Clonburris SDZ,
Dublin 22

Ronan Mac Diarmada & Associates

ADDITIONAL INFORMATION RESPONSE

November 2022

Attenuation Pond Plan

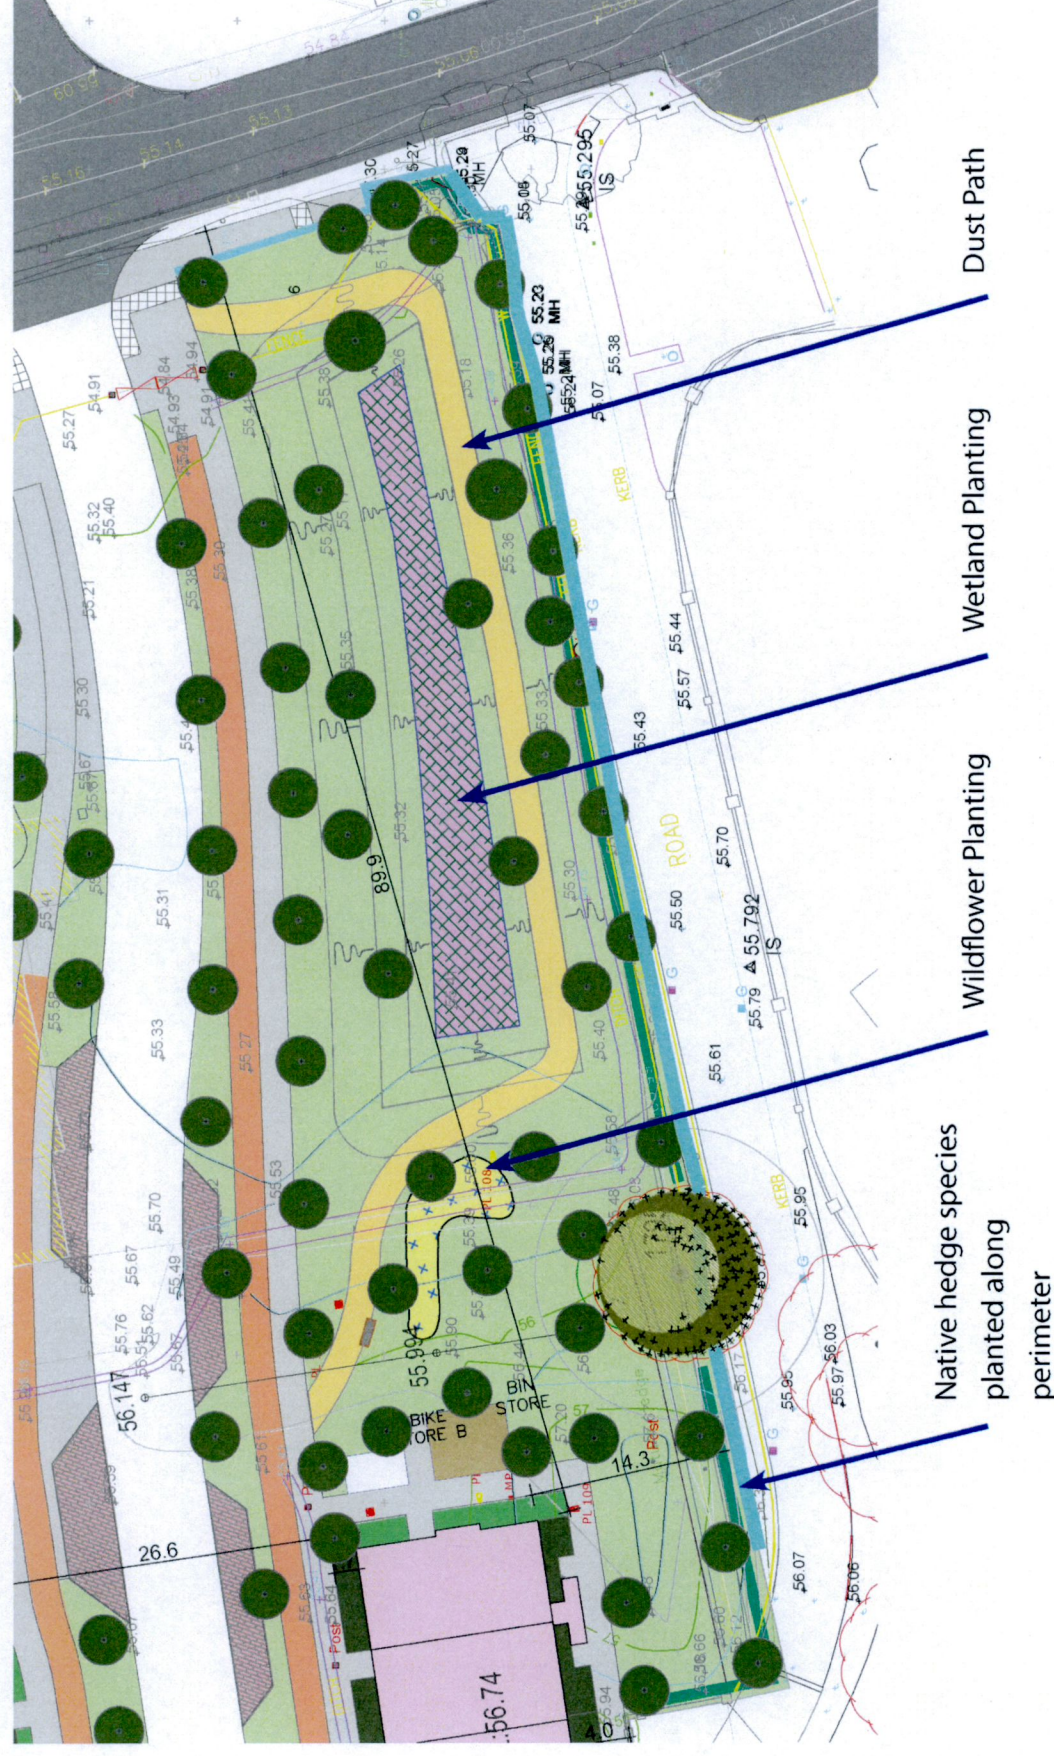
Overall revised landscape design for this area, including the incorporation of the permitted attenuation pond.

The area to the attenuation pond has been designed to allow a usable space, dust paths will allow for circulation in the space. Wildflower & Wetland planting have been accommodated to provide biodiversity to the space.

Suitable tree planting and vegetation has been picked to further enhance the area

Open & Communal Open Space Plan

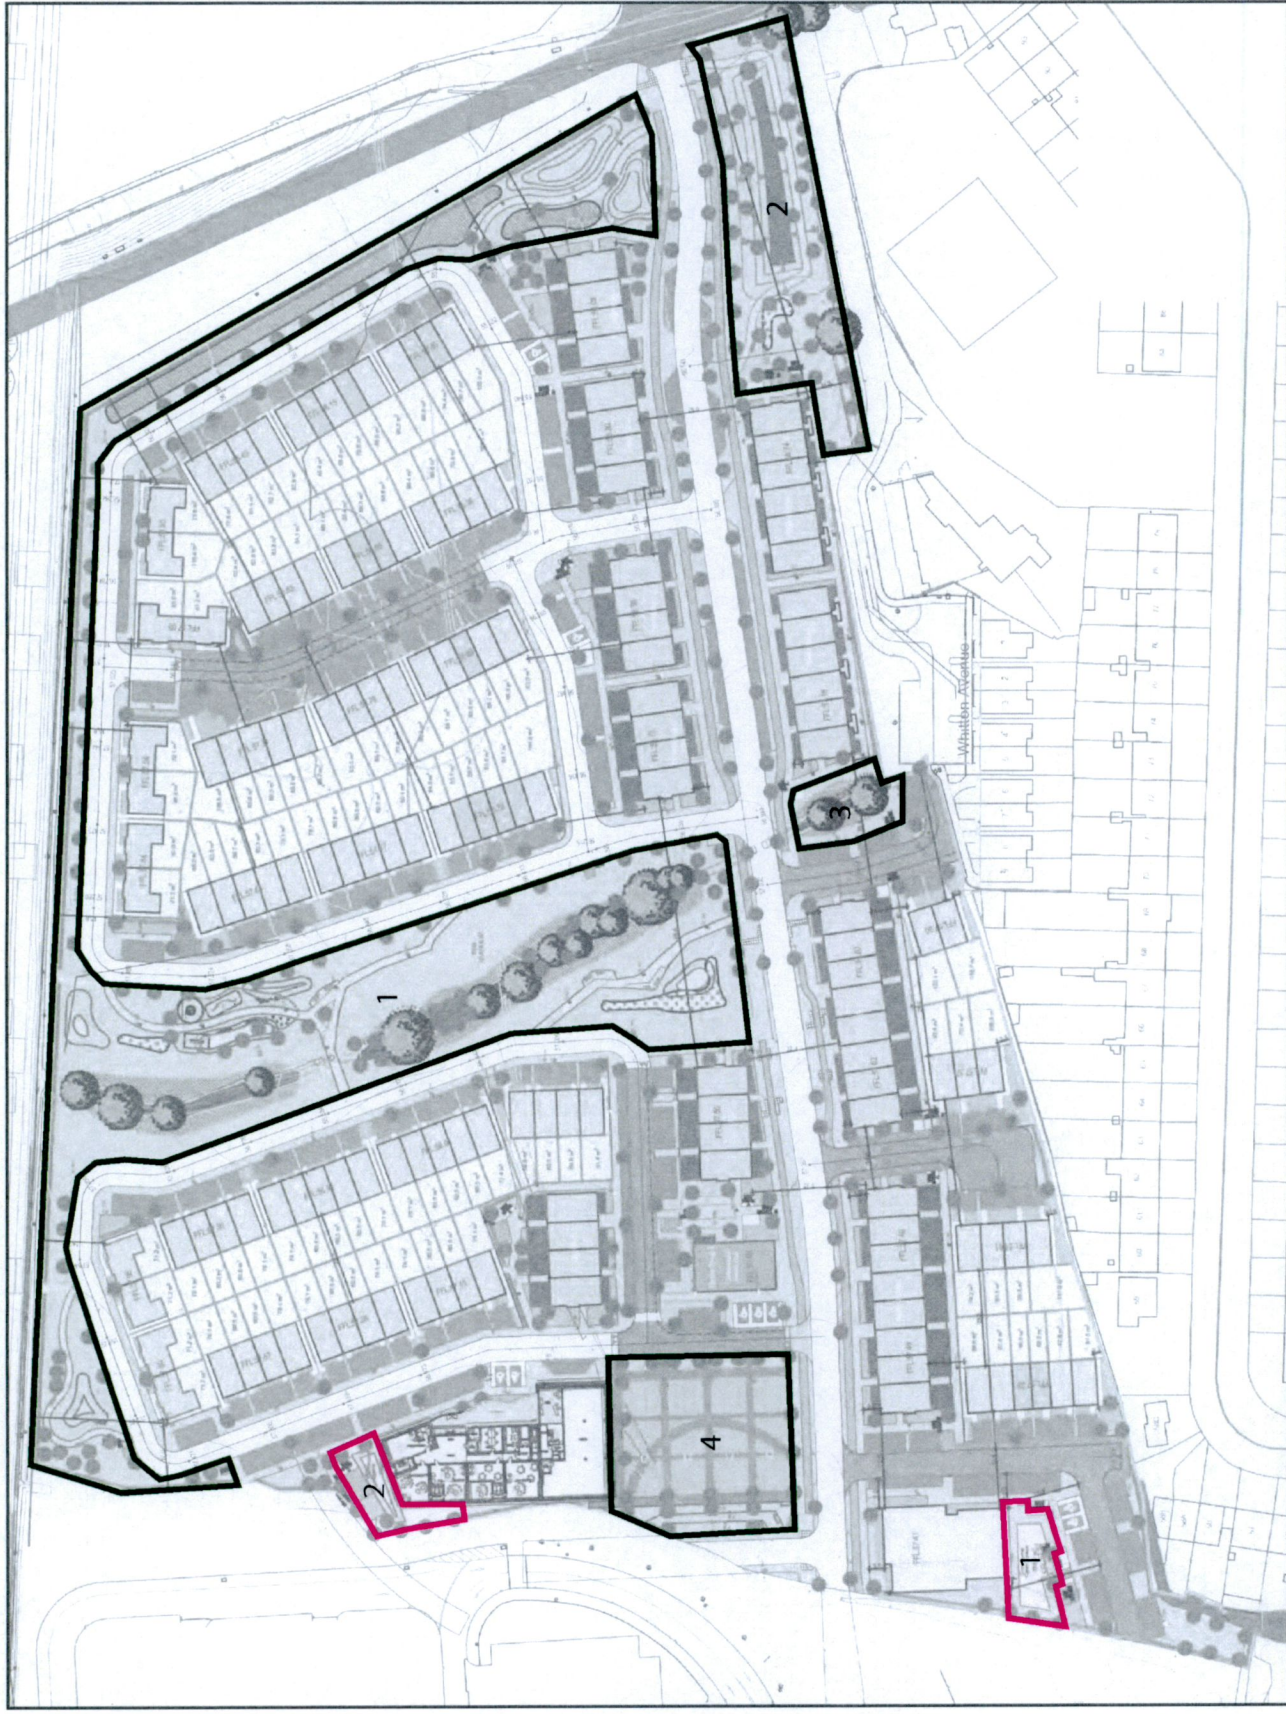
Further detail and a revised design for communal open space should be submitted. This include revised boundary treatment, consideration of sunlight access and how it will tie in with potential development to the west.

Please refer to Dwg 01. Landscape Plan for more information on Communal open space treatment.
A 1.2m railing will be implemented along the boundary of the communal open space.

Section Plan

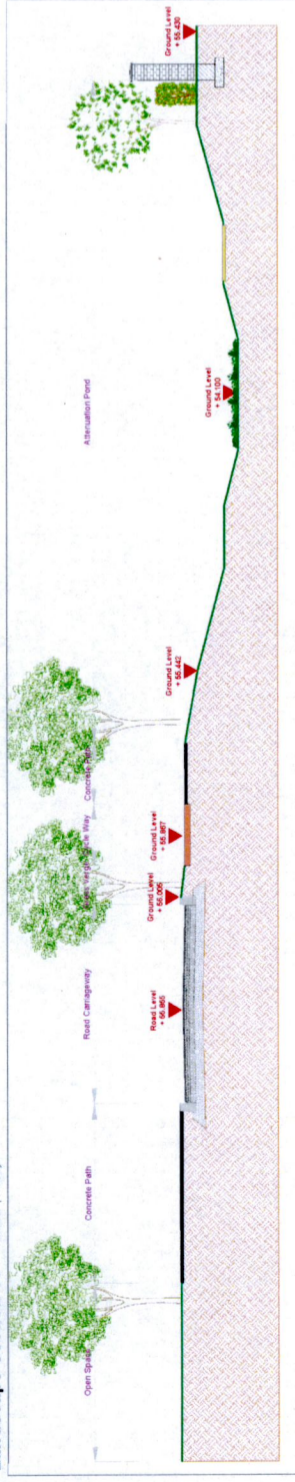
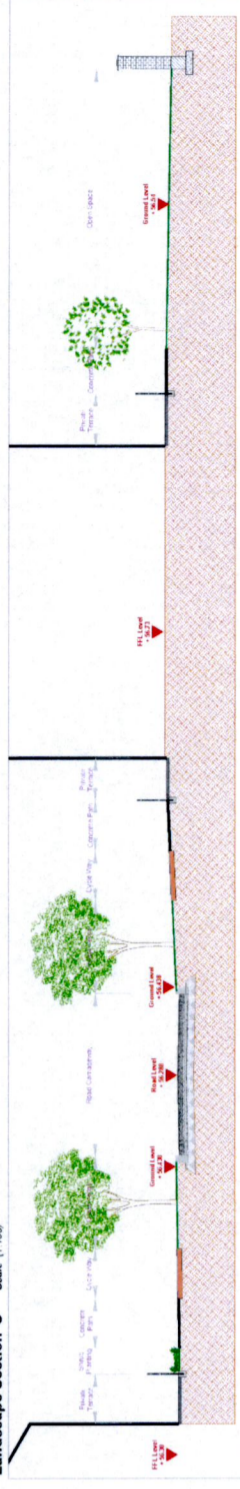
A revised layout not less than 1:200 scale showing the cross sections of the roads confirming the layouts as described in the SDZ planning scheme within the development.

Please refer to Dwg 01 Landscape Plan for road treatment and Dwgs. 03 i-iii Sections for more details on road treatment. Sections are set to 1:100 scale.

Section Plan

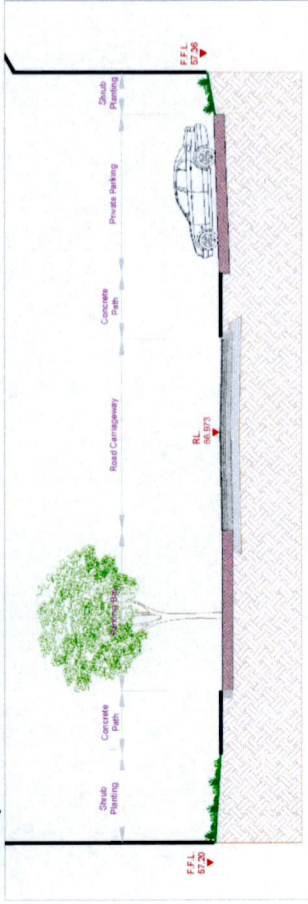
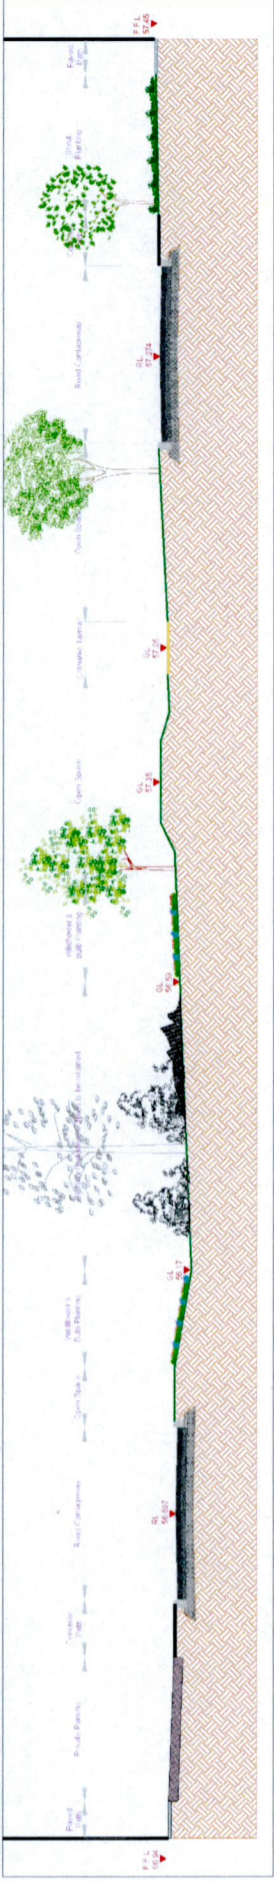
A revised layout not less than 1:200 scale showing the cross sections of the roads confirming the layouts as described in the SDZ planning scheme within the development.

Please refer to Dwg 01 Landscape Plan for road treatment and Dwgs. 03 i-iii Sections for more details on road treatment. Sections are set to 1:100 scale.

Section Plan

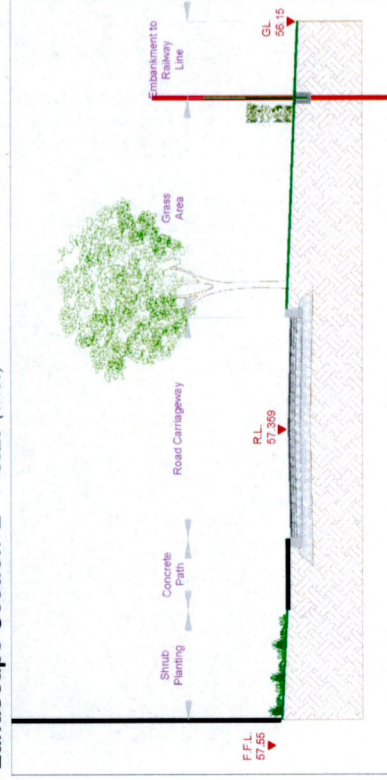
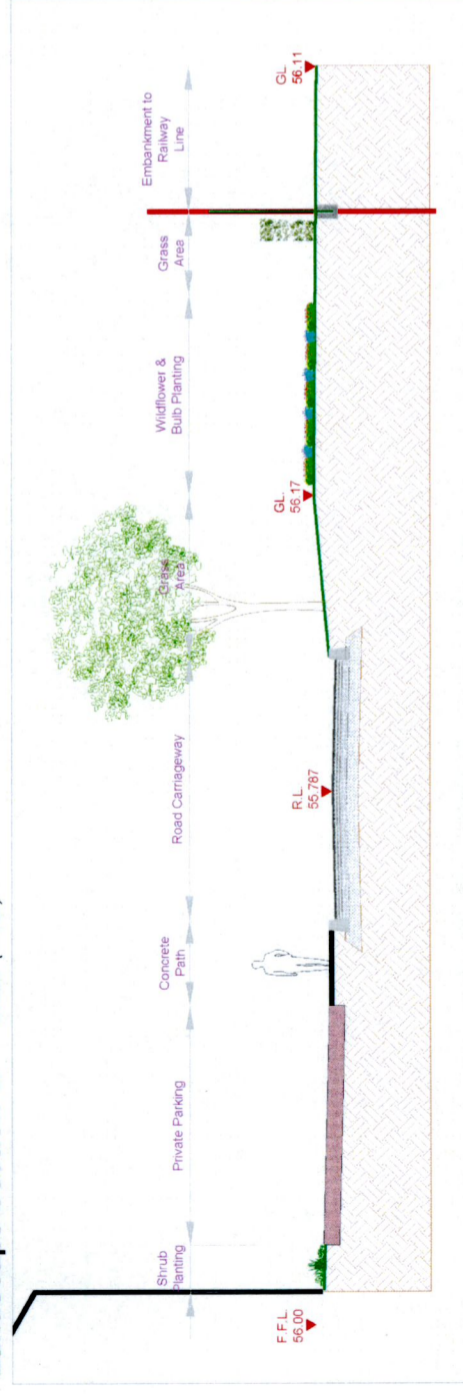
A revised layout not less than 1:200 scale showing the cross sections of the roads confirming the layouts as described in the SDZ planning scheme within the development.

Please refer to Dwg 01 Landscape Plan for road treatment and Dwgs. 03 i-iii Sections for more details on road treatment. Sections are set to 1:100 scale.

Hedgerow Implementation Plan

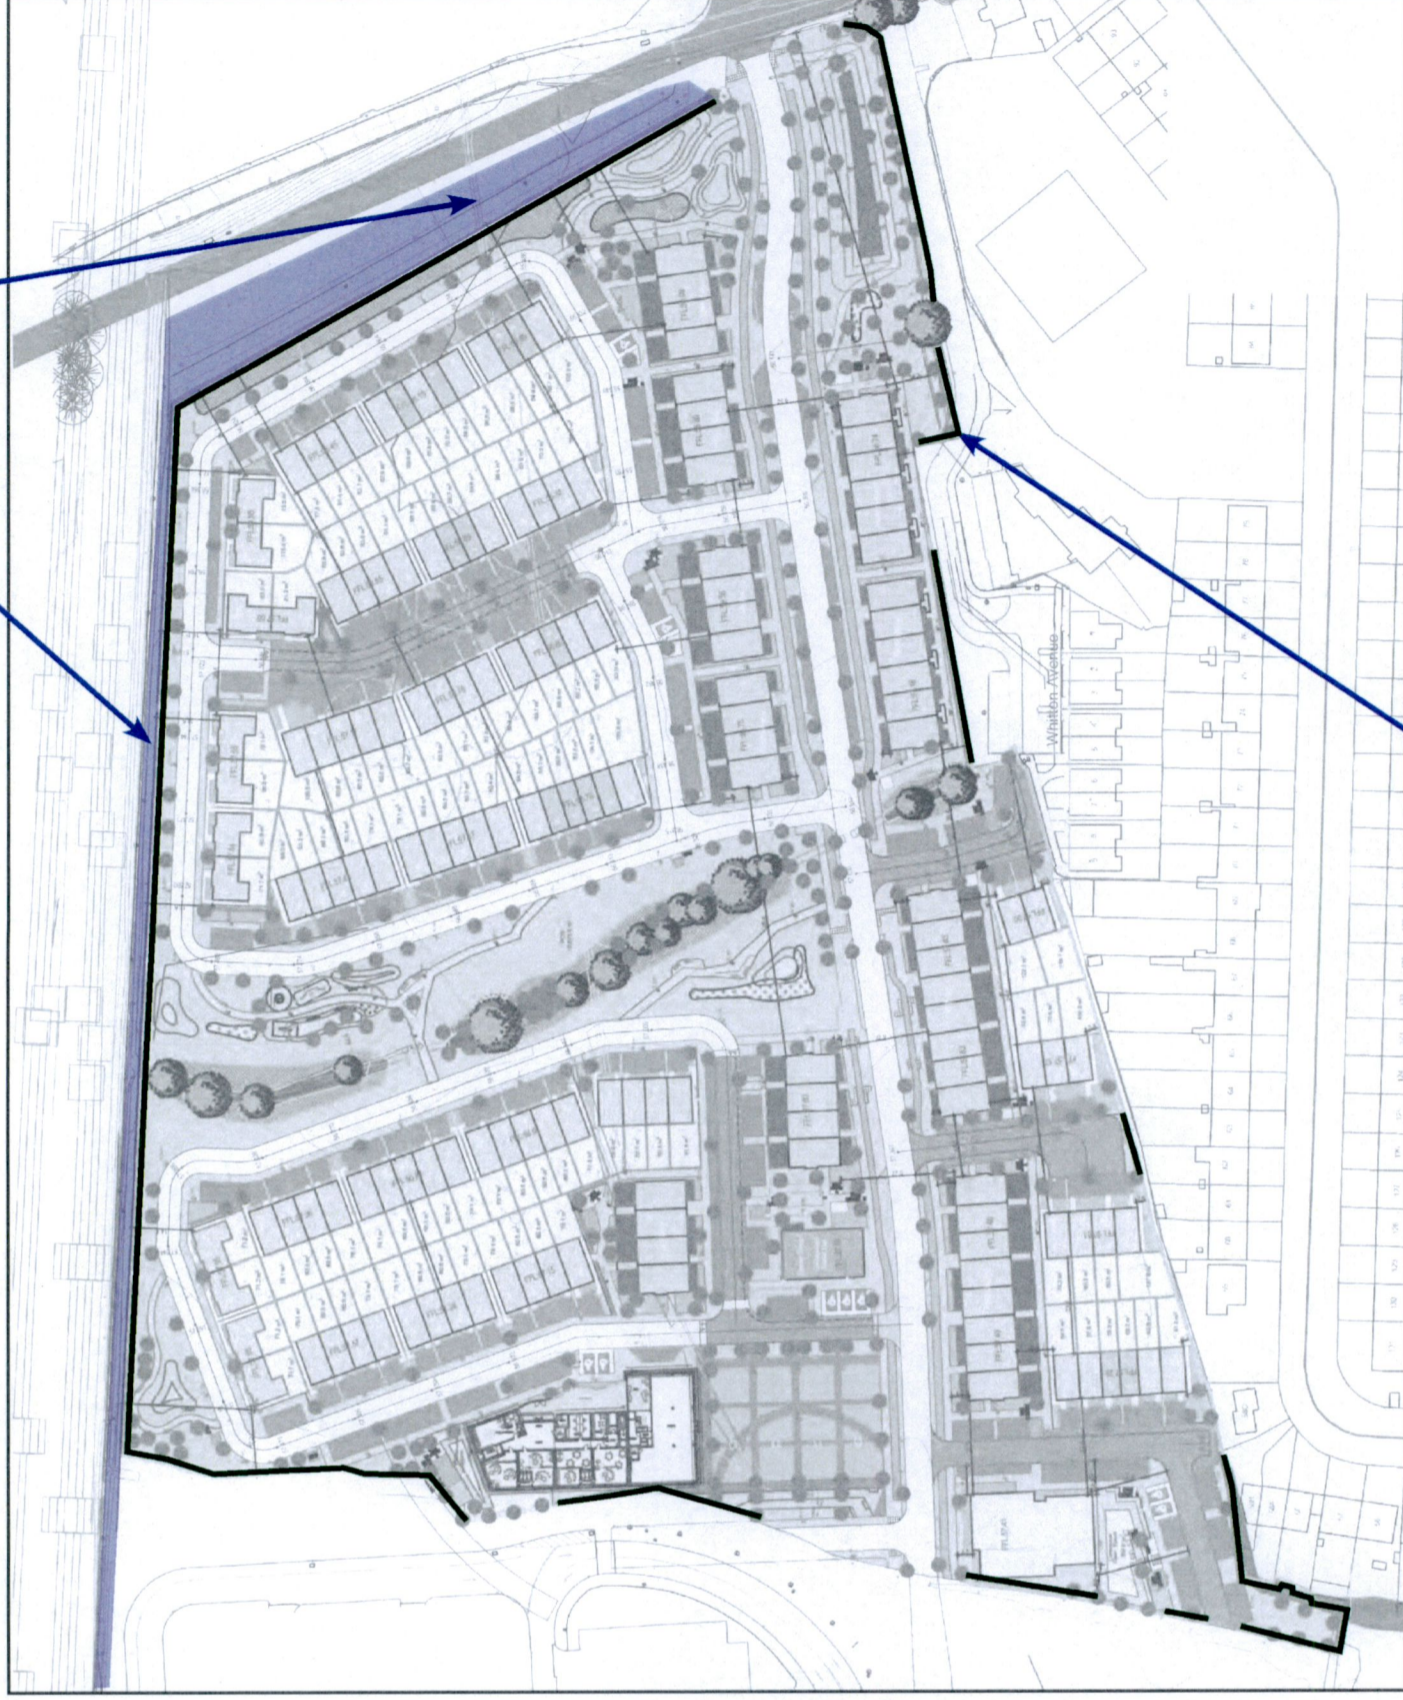
The retention of the north south tree line/hedgerow helps provide the Local Green Corridor running through the site. The proposal has the potential to contribute to the indicated green corridors along the northern and eastern boundaries of the site. Narrow strips of open space are proposed along these boundaries. However, the applicant is requested to extend the site boundary to the railway line to the north and bridge to the east and incorporate the existing pathway and open space here. The existing green palisade fence should be removed to facilitate this. Landscaping along these corridors should make a significant contribution to the site and wider green infrastructure network. Revised plans should be submitted via additional information.

We wish to retain the vegetation along the railway line to the North & the bridge to the East.

We are proposing to retain the North/South tree line as a green corridor.

The applicant/client is not in possession of the lease lands & therefore cannot exceed the site boundary North or East.

We are proposing to retain the existing boundaries to the North of the Railway line & to the east by the bridge.

It is proposed to plant a native hedge & trees along the Northern & Eastern Boundary.

Existing & New Native Hedge Plan

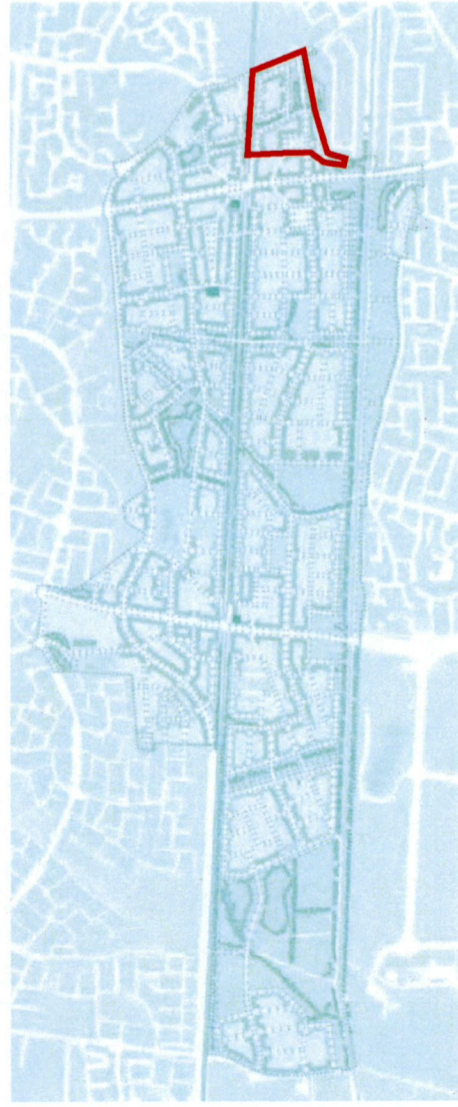
The applicant is requested to demonstrate compliance with the agreed Parks and Landscape Strategy for the SDZ, including designing and contributing to the Strategic Green Corridor along railway. A revised proposal taking account of the Parks and Landscape Strategy is required.

The proposed scheme has allowed for the implementation of native hedge and trees throughout the northern boundary (Railway Strategic Green Corridor)

Where there are hedgerows removed, a native hedge will be planted to mitigate any loss from the development.
